November 2019
FL821A

Emissions Recall: Western Star 4900 Exhaust Pipes

**Models Affected: Specific Western Star 4900 model vehicles
manufactured March 8, 2016, through July 25, 2019.**

Fig. 1, Difference in the Shape of the Tube and Bracket Mounting Location

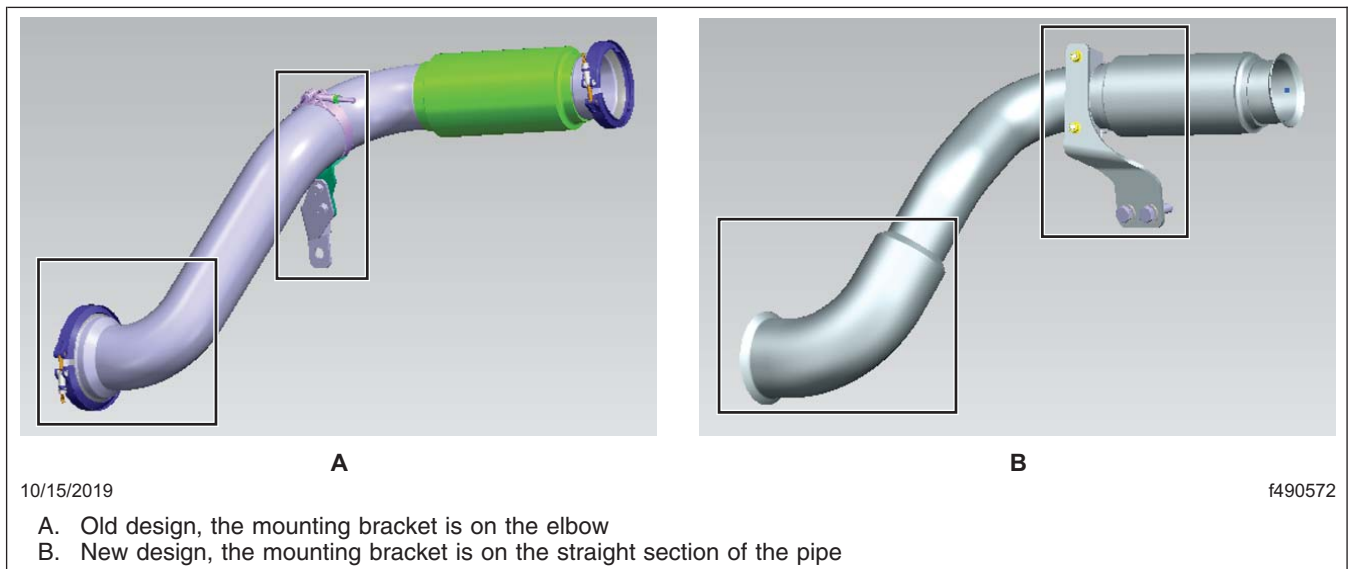
On certain vehicles the exhaust pipe support bracket lacks durability. This can cause the exhaust pipe to crack at the bellows and weld breaks to occur at the flange, which can lead to exhaust leaks.

1. Check the base label (Form WAR259) for a completion sticker for FL821 (Form WAR260) indicating this work has been done. The base label is usually located on the passenger-side door about 12 inches (30 cm) below the door latch. If a completion sticker is present, no work is needed. If a completion sticker is not present, continue with the next step.
2. Park the vehicle on a level surface, shut down the engine, and set the parking brake. Chock the tires.
3. Compare the pipe shape and mounting bracket location, see [Fig. 1](#).
 - If the new pipe and mounting bracket have been installed, no work is needed. Go to step 4.
 - If the new pipe and mounting bracket have NOT been installed, go to Exhaust Pipe Assembly Procedure.

A newly designed exhaust pipe and support bracket will be installed between the turbo and Aftertreatment Device, behind the front passenger wheel.

Fig. 2, Exhaust Pipe Assembly Replacement

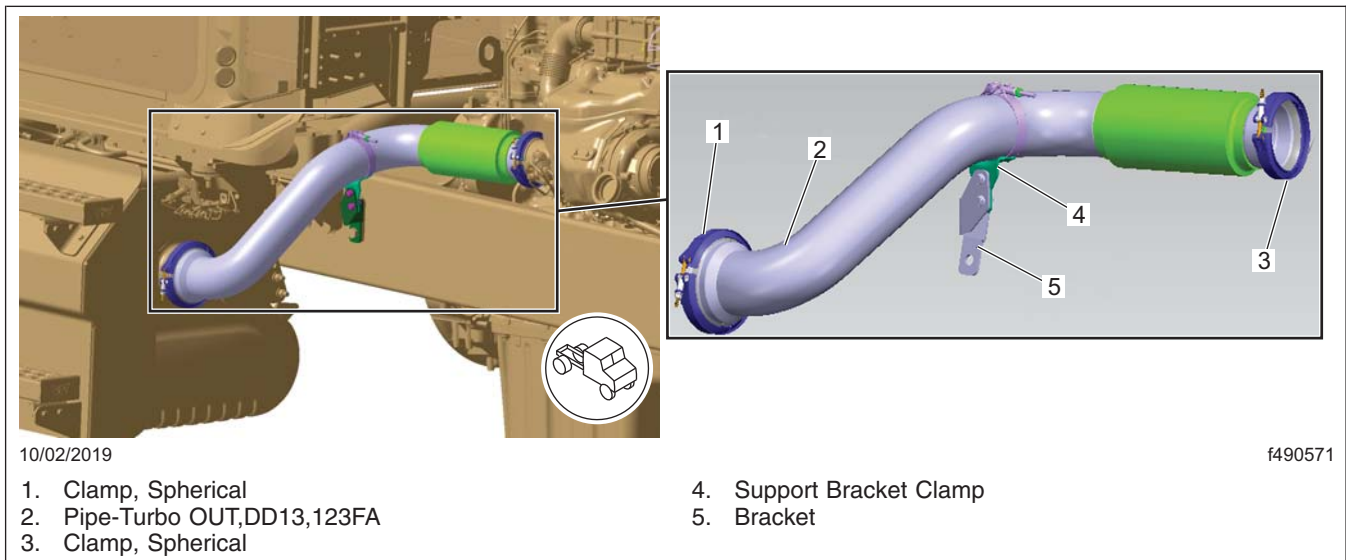
1. Disconnect the batteries.
2. Using **Fig. 2**, remove the exhaust pipe, and support bracket between the turbo outlet and Aftertreatment Device (ATD).
3. Remove the spherical clamps at the ATD and the turbo outlet.
4. Remove the support bracket clamp. See **Fig. 2**, ref 4.
5. Remove the original exhaust pipe assembly.
6. Remove the original support bracket (**Fig. 2**, ref 5) from the cab cross member bracket, and reinstall the fasteners. Tighten the fasteners 128 lbf·ft (174 N·m).
7. Check the back of the frame rail for components that could be damaged from drilling. Remove any components as necessary.

Fig. 3, Drilling Locations for New Exhaust Support Bracket on Frame

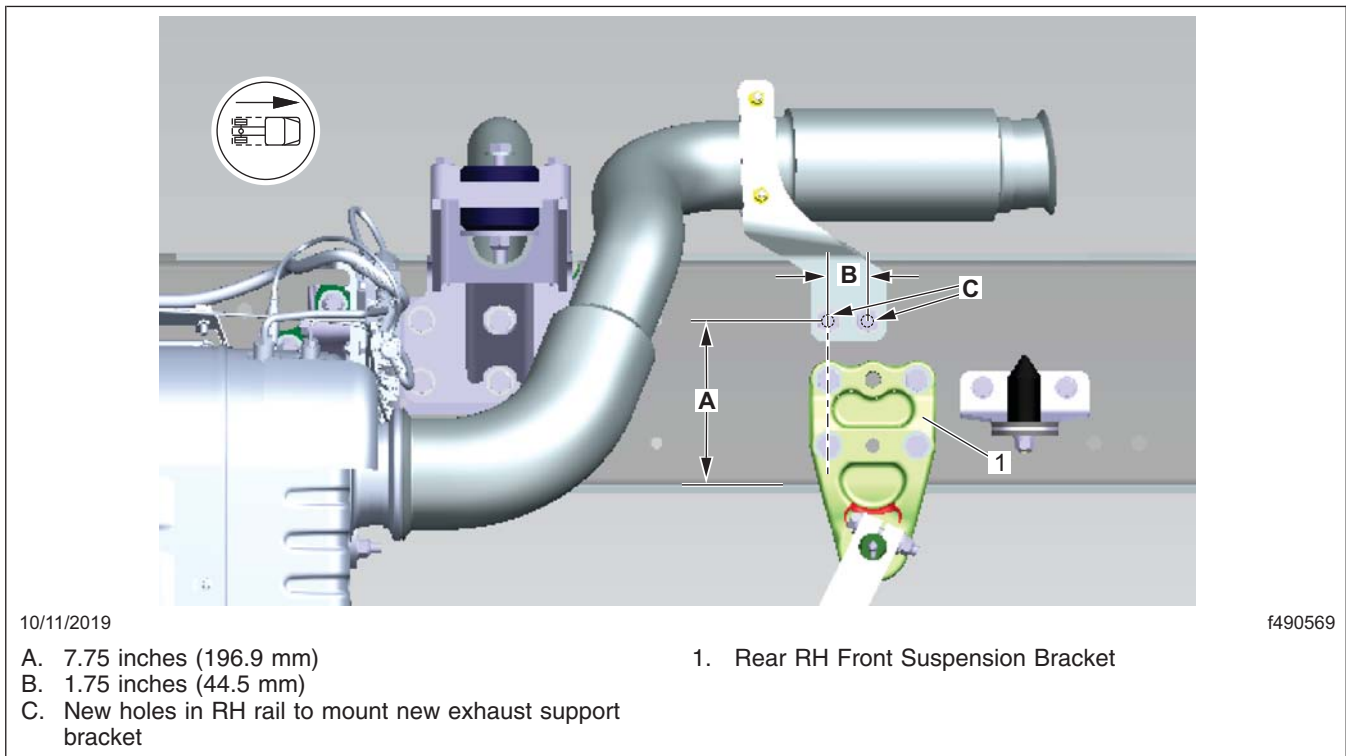
8. Using **Fig. 3**, mark the locations for the support bracket mounting fastener holes.
9. Position the old spherical clamps on the turbo outlet and ATD.
10. Fit the new pipe assembly so that the pipe flairs are as centered as possible at both the ends, and loosely install the clamps to locate the assembly in that position on the ports.

- The two support bracket drill locations are parallel with the top of the frame rail.
13. Remove the pipe and clamps.
14. Drill two 11/16-inch (17.5-mm) holes in the frame.

Fig. 4, New Pipe Assembly Installation

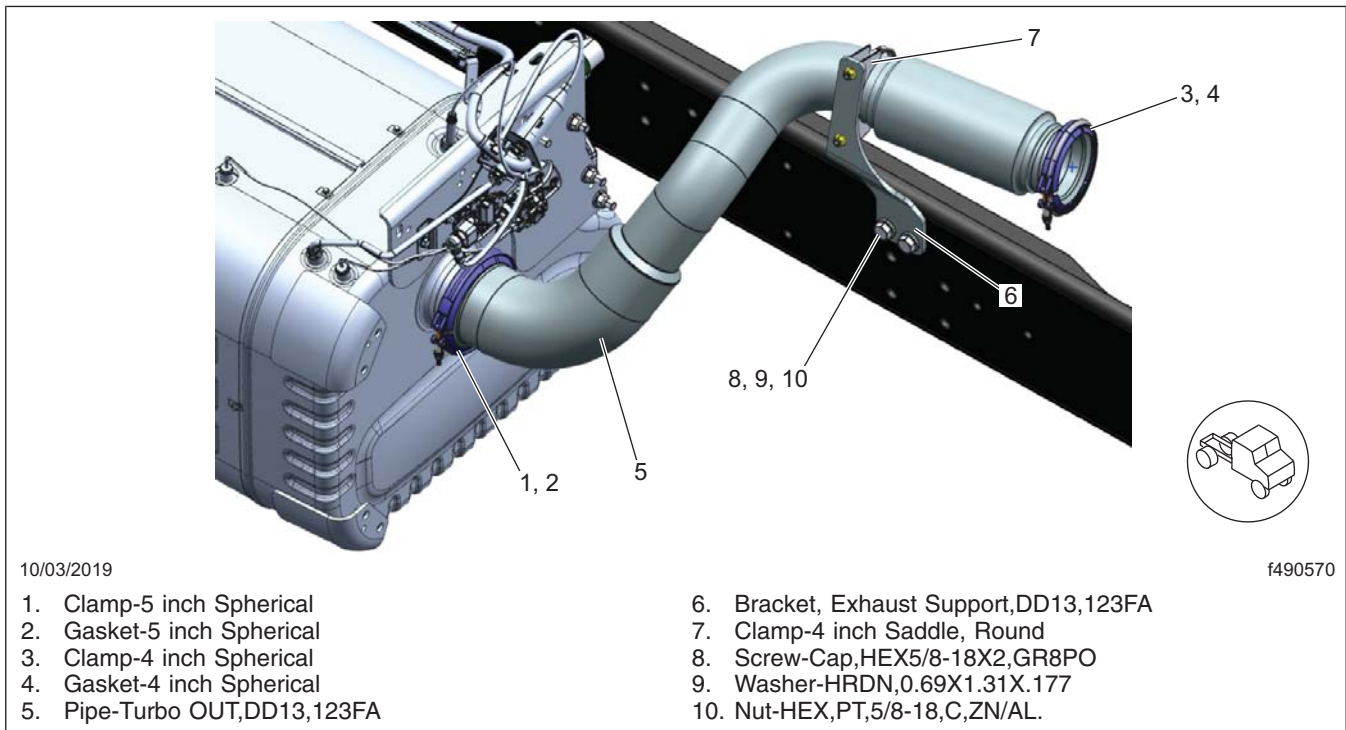
11. Loosely install the U-bolt (**Fig. 4**, ref 7) securing the support bracket (**Fig. 4**, ref 6) to the pipe assembly.
12. Compare the pipe support bracket bolt locations to the marks on the frame, and confirm the locations are correct. Below is the list of characteristics to inspect.

21. Install the pipe support bracket (**Fig. 4**, ref 6) on the frame, and secure the fasteners (ref 8, 9, and 10) wrench tight.
22. Fit the U-bolt (**Fig. 4**, ref 7) between the support bracket and pipe assembly.

24. Tighten the support bracket fasteners to 128 lbf-ft (174 N-m).
25. Tighten the spherical clamps at the turbocharger outlet, and the ATD inlet connections as follows.

- 25.1 Tighten the nut 126 to 138 lbf-in (1425 to 1560 N-cm).
 - 25.2 Using a plastic or rubber mallet, tap around the outside of the clamp, in several locations, to seat the clamp against the pipe.

- 25.3 Tighten the nut a second time 126 to 138 lbf-in (1425 to 1560 N-cm).
26. Tighten the pipe support U-bolt 23 lb-ft (31 N-m).
27. Start the engine and check for leaks. Further tighten the clamps on any leaking connections as needed.
